Source Terms and Radiological Consequence Analyses

- Frankie Pimentel, Sr. Project Manager - Engineering & Risk, NEI
- Greg Broadbent, Senior Staff Engineer - Corporate Nuclear Analysis, Entergy
- Chad Burns, Sr. Fuels Engineer, Constellation Safety Analysis
- Brian L. Mount, Consulting Engineer, Nuclear Safety Analysis II, Dominion Energy

August 24, 2022

- DG-1389 contains significant changes to BWR release fractions and timing
 - Doubling halogen releases can have wide-ranging impacts
 - Charcoal/HEPA loadings and heat loads, EQ

DG Release Rates Lower than Rev. 0

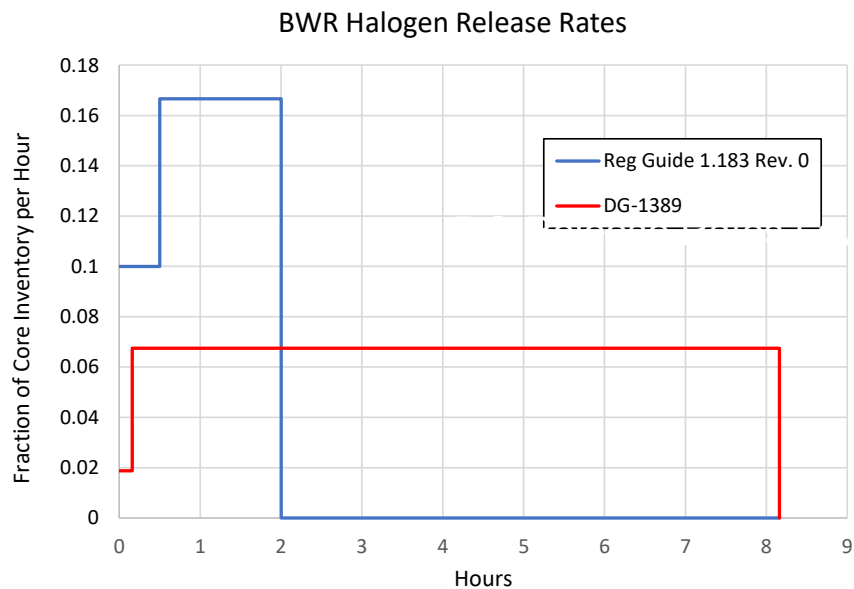
Results from Proposed Reg Guide Changes

Results from Proposed Reg Guide Changes

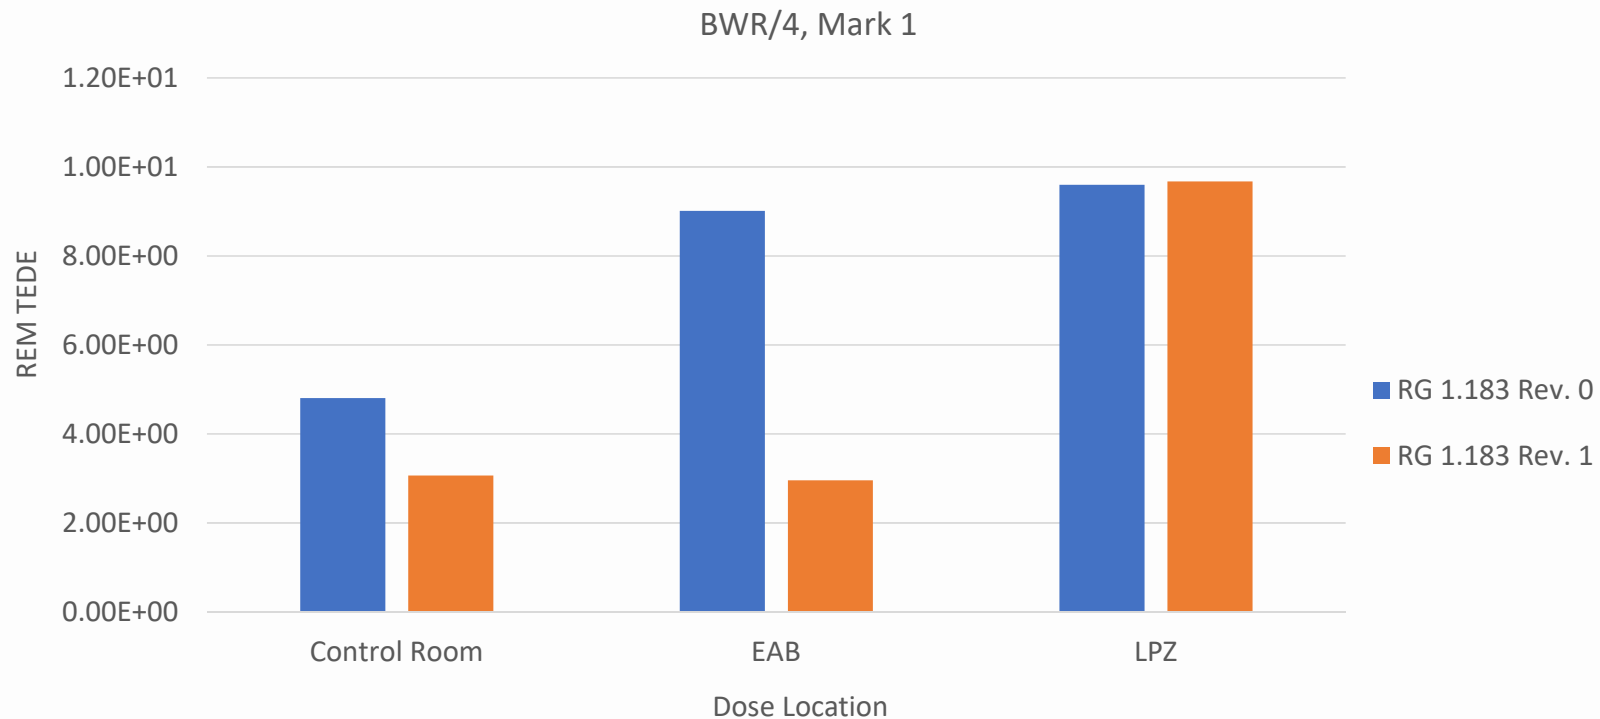
- Results with condenser compartment added to Rev. 1 case
